DESIGN REVIEW COMMISSION AGENDA

DESIGN REVIEW COMMISSION STAFF REPORT

SUBJECT: DR-2-17: REQUEST FOR A SECOND MEETING WITH THE DESIGN REVIEW

SUBJECT: DR-3-17: REQUEST FOR AN EARLY DESIGN CONSULATION WITH THE DESIGN

SITE MASSING:

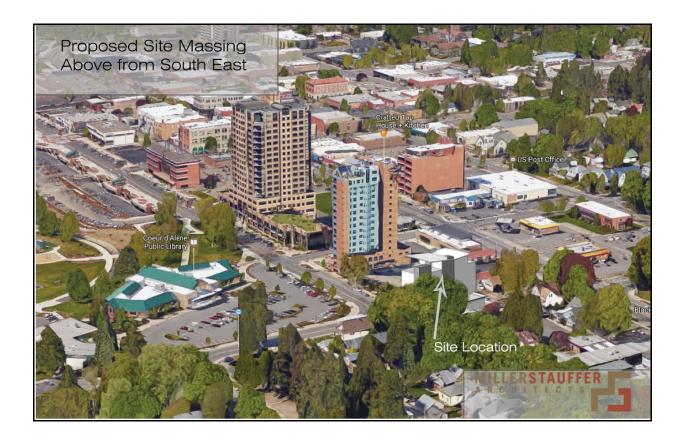
Commissioner Lemon inquired about the slide showing the progression to the neighborhood. He noted that it is a great slide showing how the applicant is trying to bring the building to scale to the neighborhood.

Commissioner Gore stated that he remembers seeing the graphic in a text book. He feels that people don't realize when working with two different zones that it prevents doing a solid wall.

Commissioner Lemon inquired about the rendering showing the roof on the (DO-E) and inquired if the applicant can explain the design.

Commissioner Lemon stated that he is concerned that you can't have a flat roof in the (DO-E).

Mr. Stauffer explained that the roof has a "reversed" roof and that the bigger side of the building is in the (DC).

ELEVATION AND GENERALIZED MASSING: SOUTH AND EAST ELEVATION

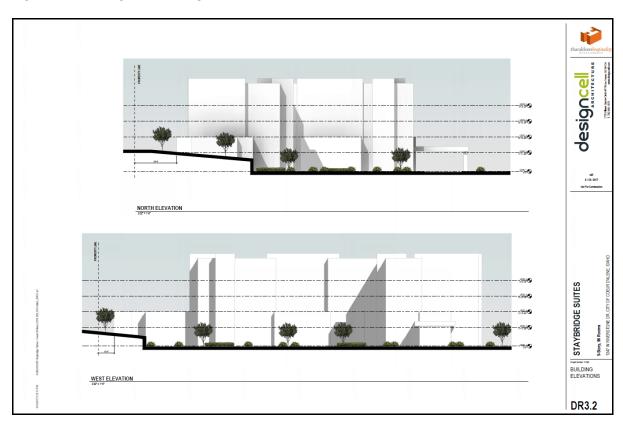
McDonald's Corporation owns the developed property to the south of the proposed Staybridge Hotel development. We would like to take this opportunity to express some concerns we have with the orientation of the front lobby of the proposed building and the parking plan for hotel guests and employees. Although we had been working with the Tharaldson people to try designate some parking stalls on the McDonald's site so that the hotel could meet code in exchange for other considerations to McDonald's, we were unable to finalize an agreement. We have not spoken with Tharaldson or their representative since mid-January.

- The lobby of the hotel faces the McDonald's, which means both businesses most convenient parking will be in the same parking field. The hotel has a row of 14 stalls against their building and some will need to be ADA compliant stalls or designated for check-in. We think this will cause parking issues between the businesses when hotel employees and overnight guest choose parking closest to the lobby which may actually be on McDonald's parcel. There is no division planned between the parcels as we share an access driveway. We propose that if the building lobby will remain oriented to the south that the following conditions be considered:
